ADDENDUM NO. 1
to
Bidding Documents for:

Town of Wareham, MA
Installation of Low-Pressure Sewer Force Main
Contract 2022-001

The following changes and additional information are hereby made part of the Bidding Documents:

SHEET NO. C-1

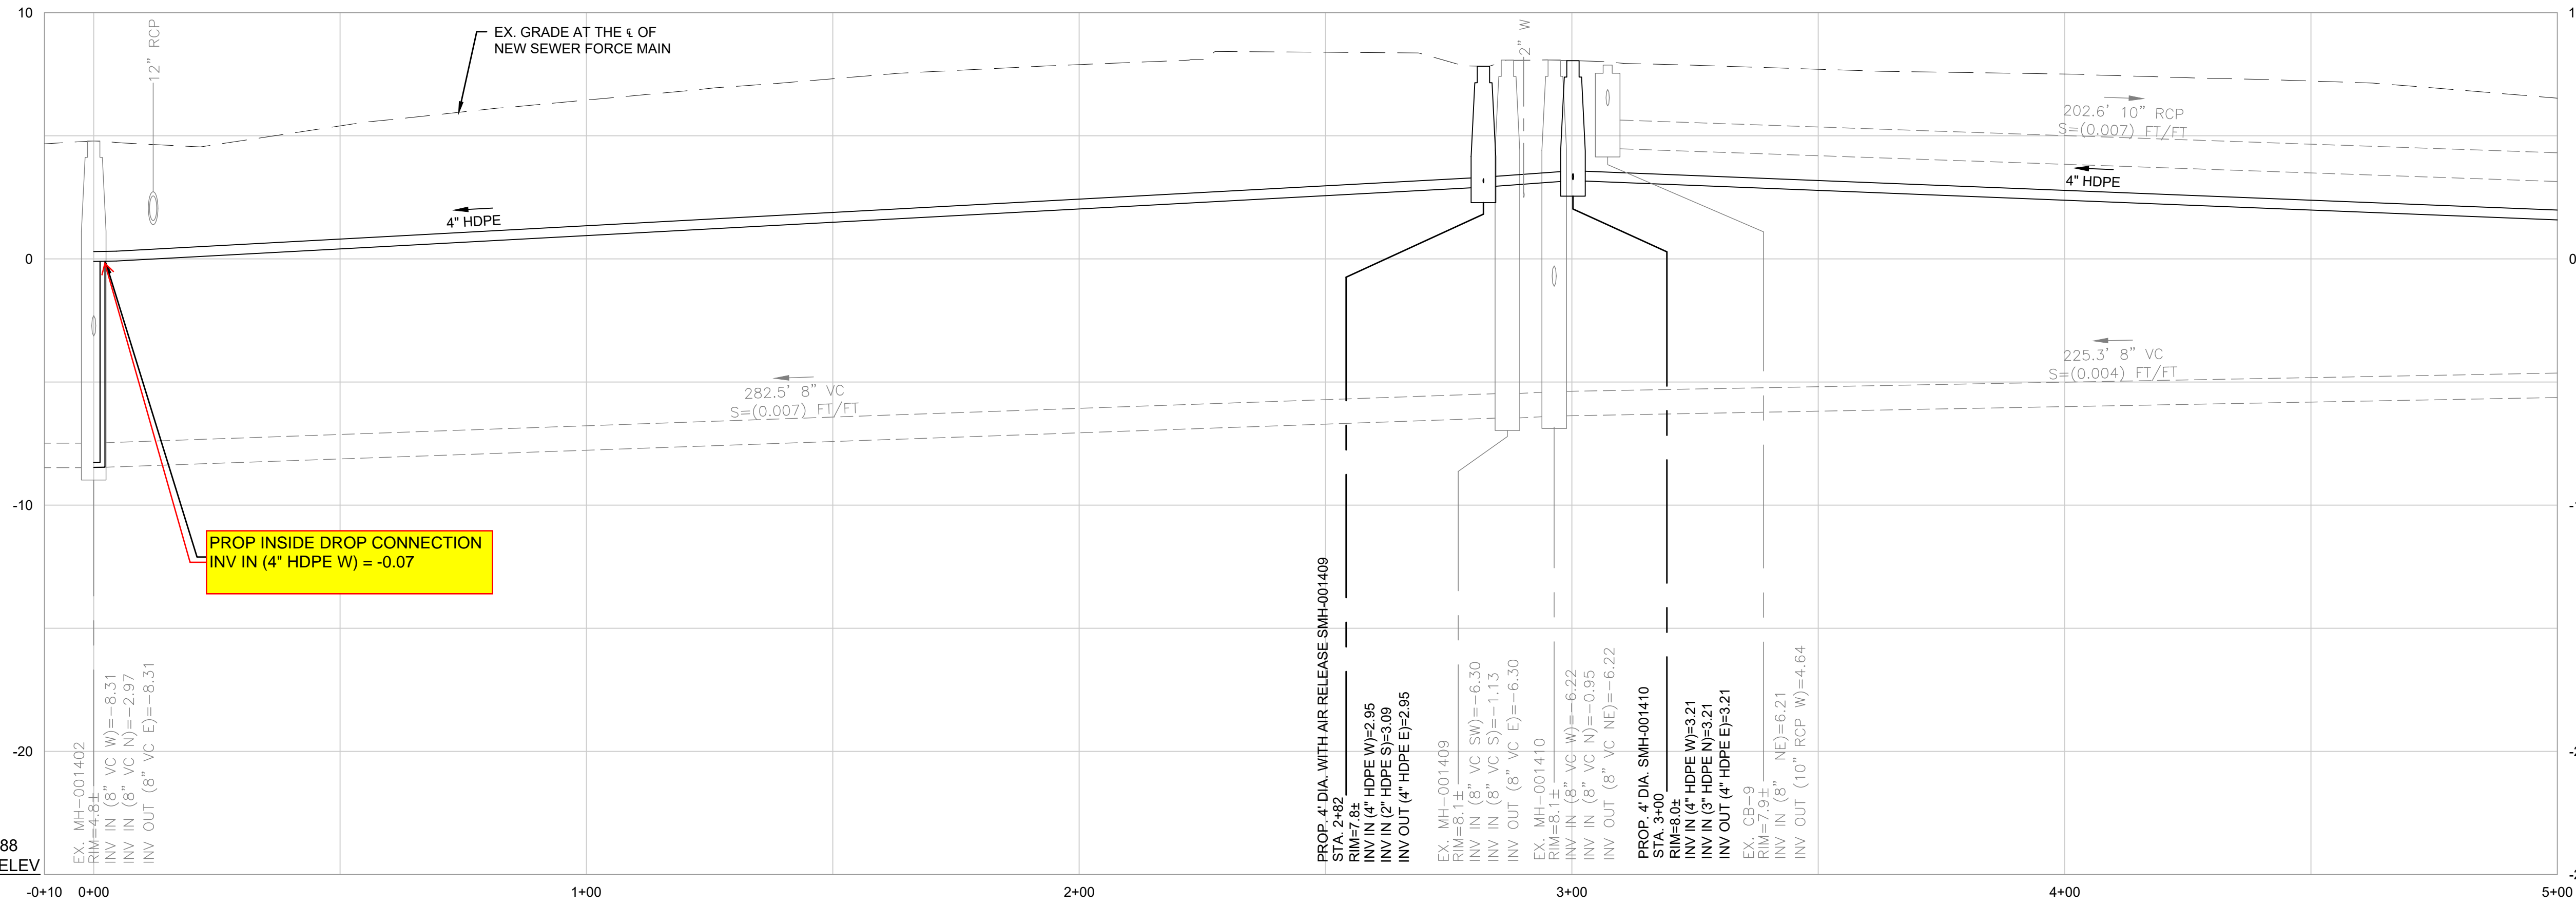
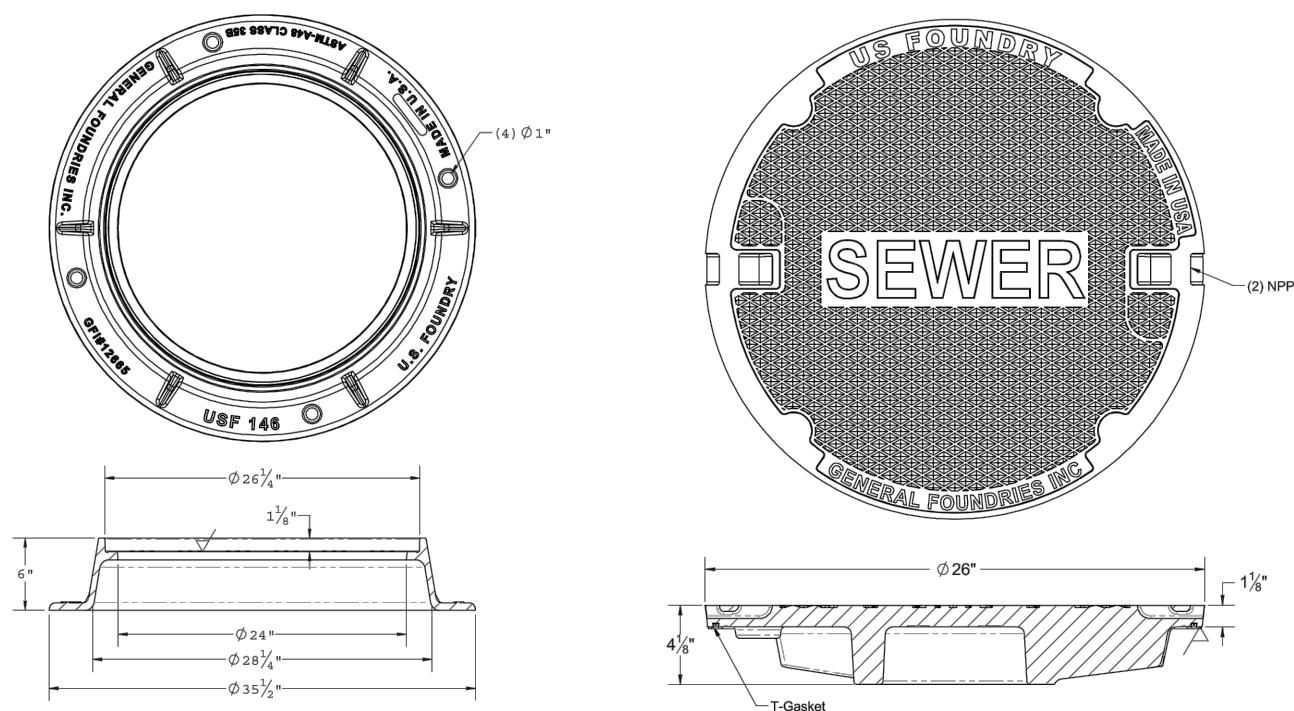
Delete sheet C-1 in its entirety and insert the attached revised sheet C-1. Changes are shown with yellow callouts.

20. **Q:** Please clarify the last sentence of Note 14 on plan sheet C-1. “Grinder pump cores, electrical, venting and connection to existing gravity service will be completed by others.”

A: The pumps are not to be installed inside the pump station tanks, the electrical conduit, vent pipe and gravity service pipe are to be installed as shown on the grinder pump station detail on plan sheet CD-1. Also see spec section 01015 part 1.03 for further detail.

GRINDER PUMP STATION DETAIL

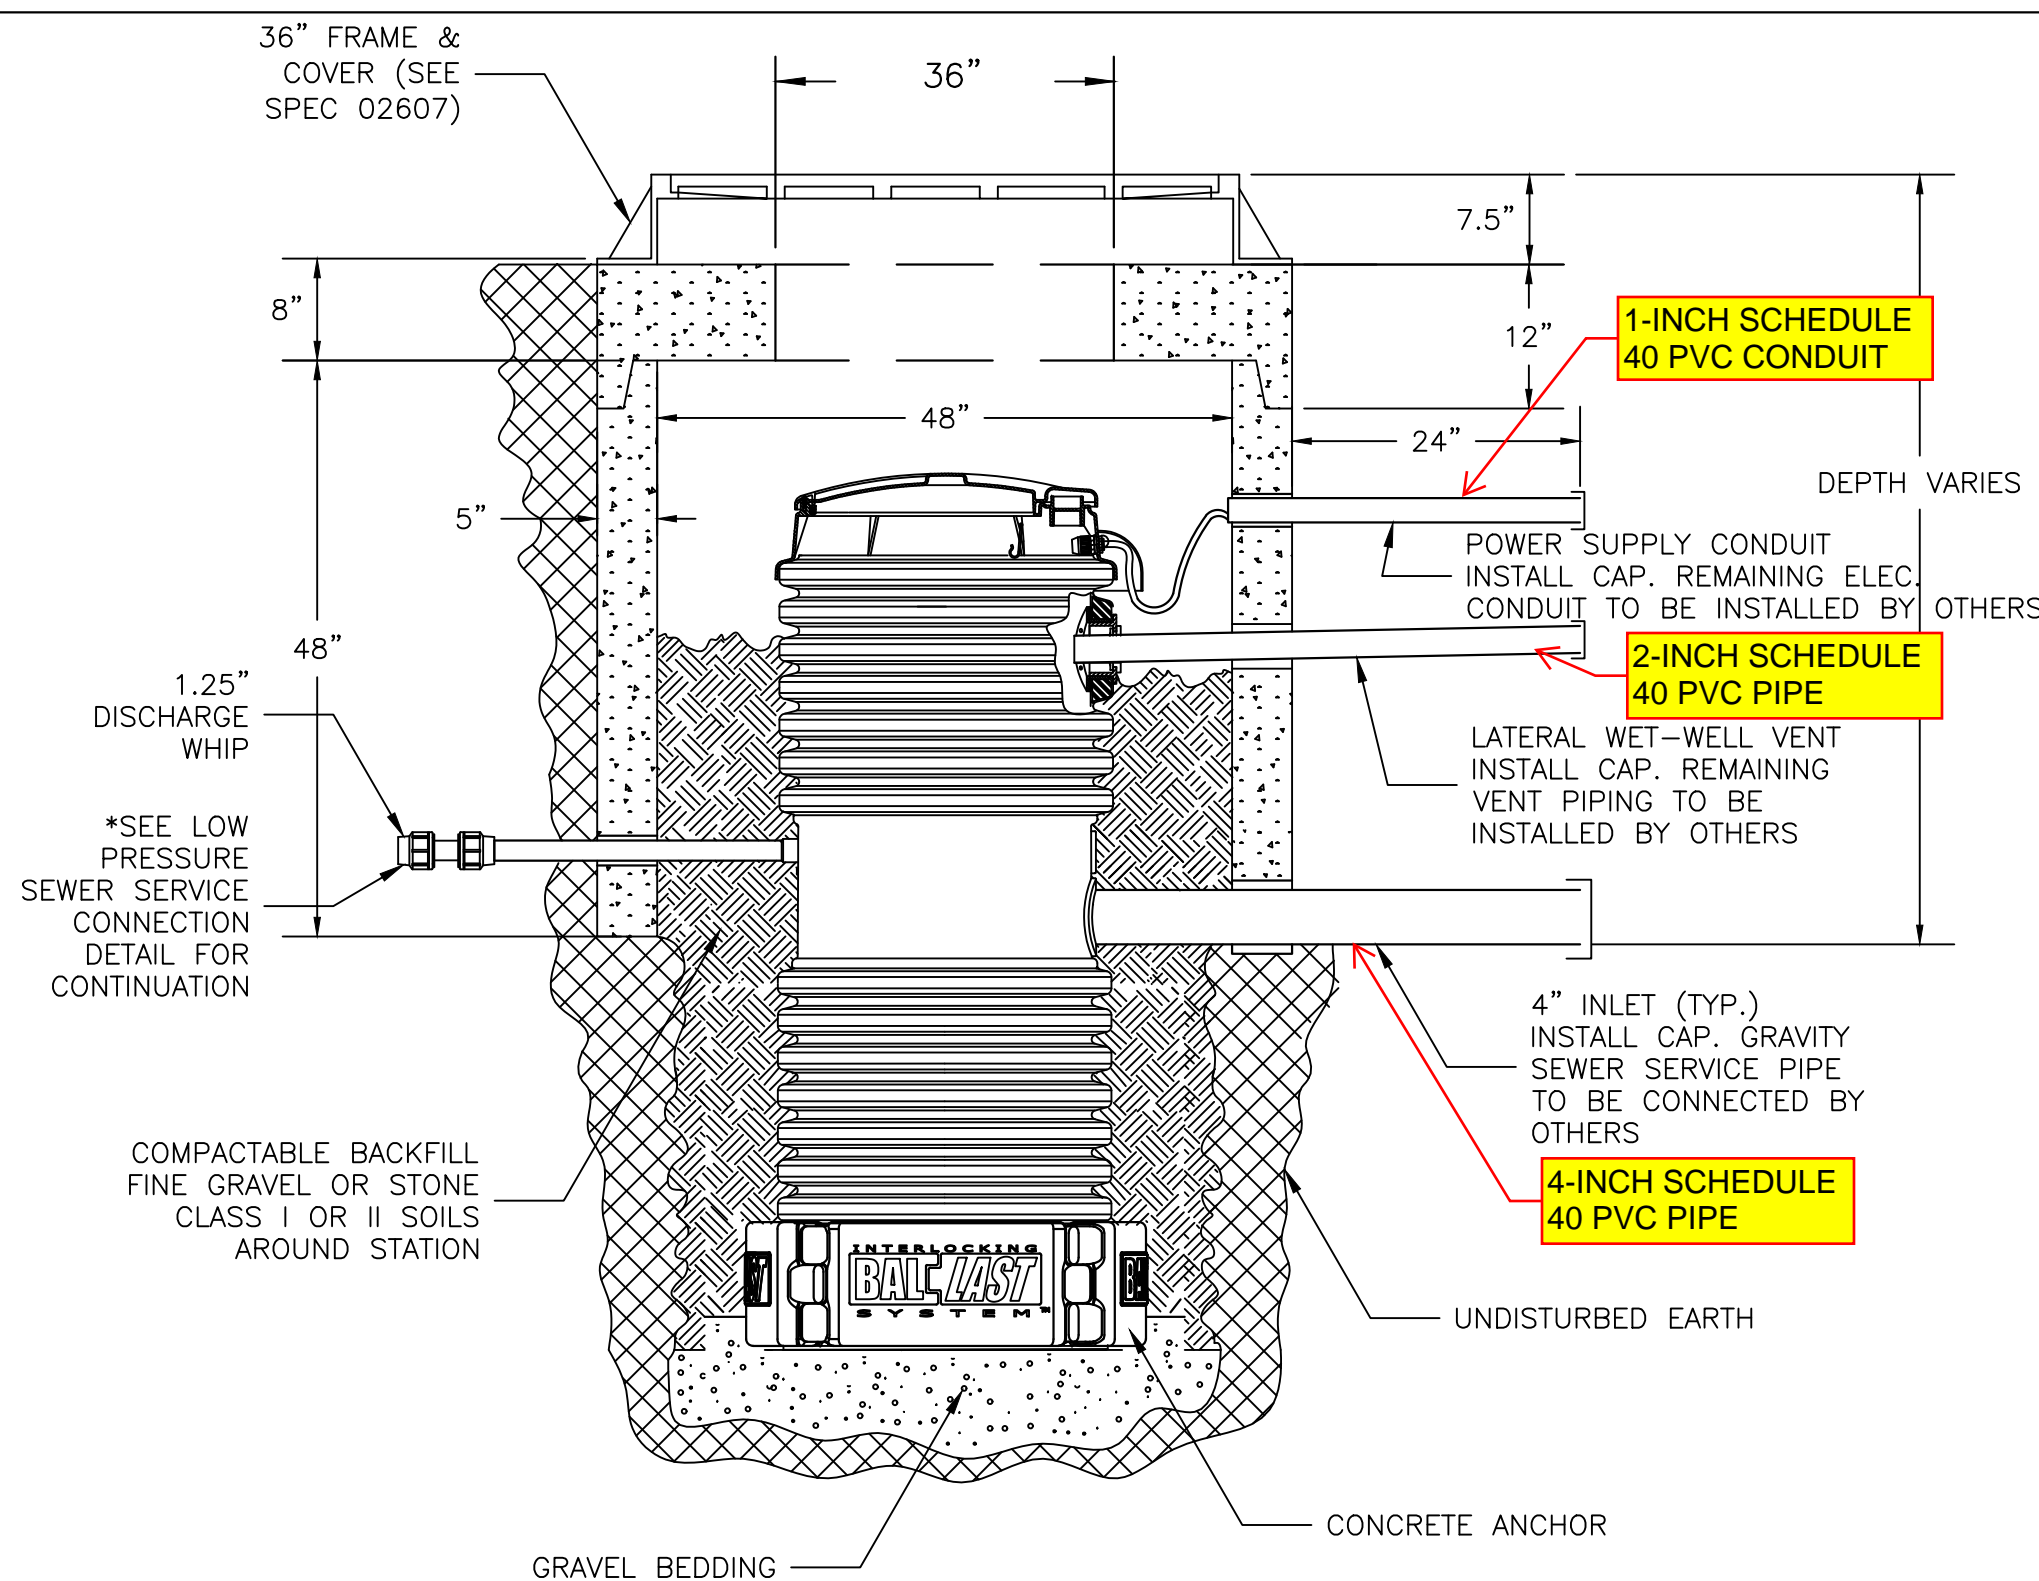
Delete sheet CD-1 in its entirety and insert the attached revised sheet CD-1. Changes are shown with yellow callouts.

2. **Q:** Referencing the detail for a sewer service on sheet CD-1 calls for a stainless steel corporation coming off a tee. With the main line being HDPE should a tapping saddles be used?

A: HDPE tees or tapping saddles may be used for the sewer services and stainless steel corporation stops can be installed on the service line in close proximity to the tee.

LOW PRESSURE IN-LINE (3-WAY) CLEANOUT STRUCTURE SECTION VIEW

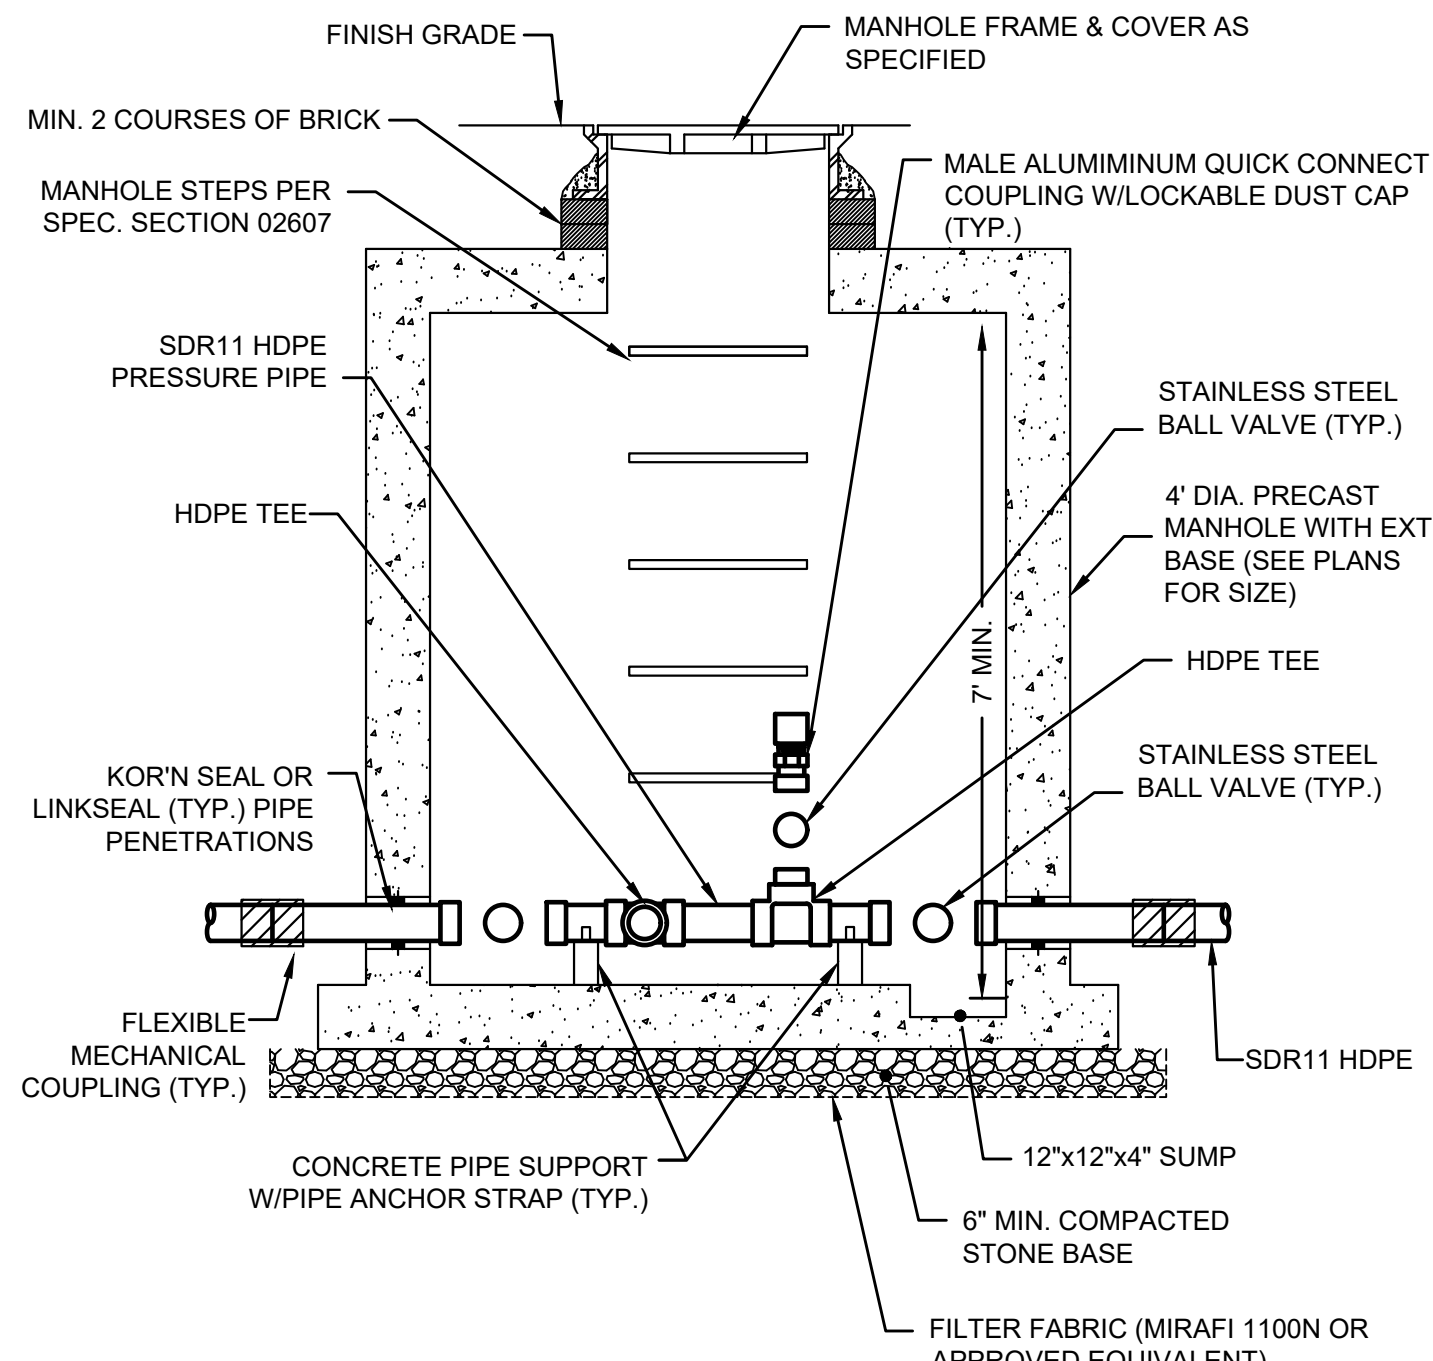
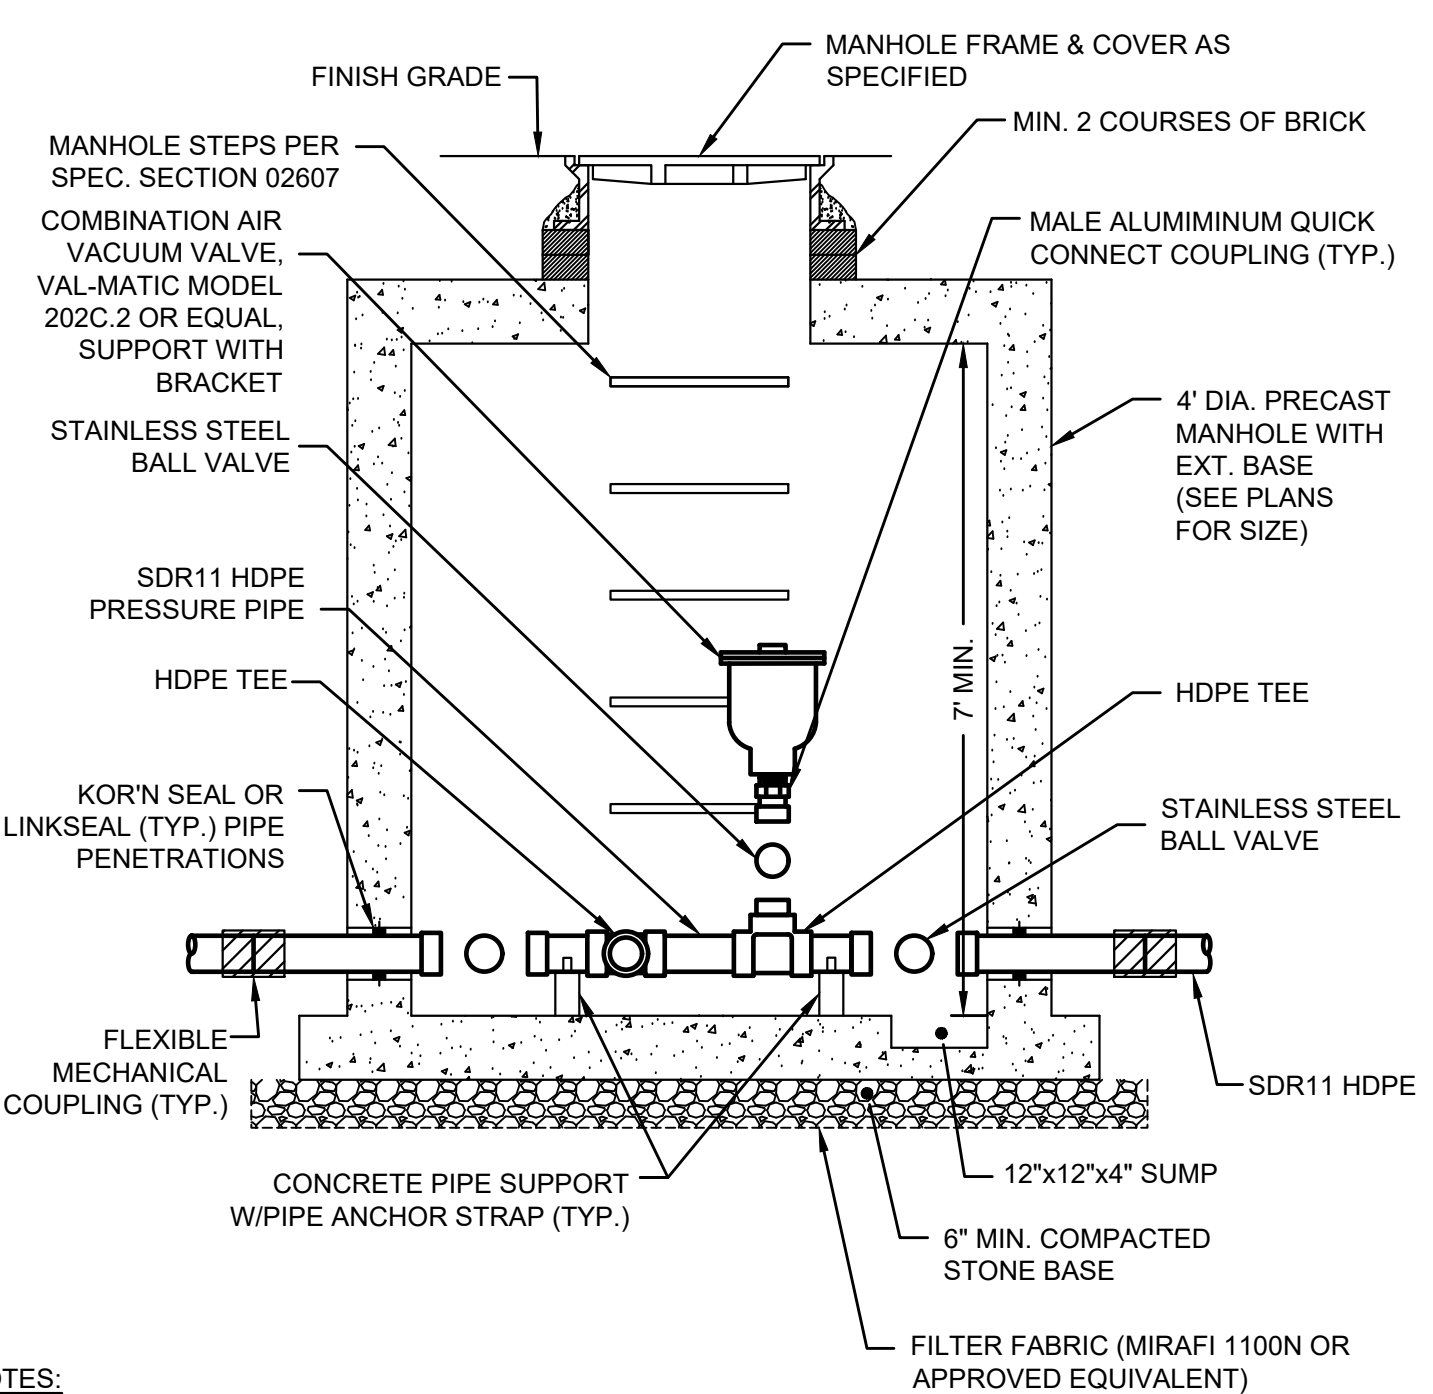
1. **Q:** Can you verify the connection types and model of gate valves to be used for Bid Items 2A, 2B, 2C, 2D, and 2E?

19. **Q:** Some manholes on the plan are called out with air releases, what are the manholes that are not called out as air releases?

A: Threaded stainless steel ball valves are acceptable for use inside low-pressure sewer manholes. See low-pressure structure details on plan sheet CD-1.

A: Manholes not called out as being air release manholes on the plans are cleanout manholes. See plan sheet CD-1 for manhole details.
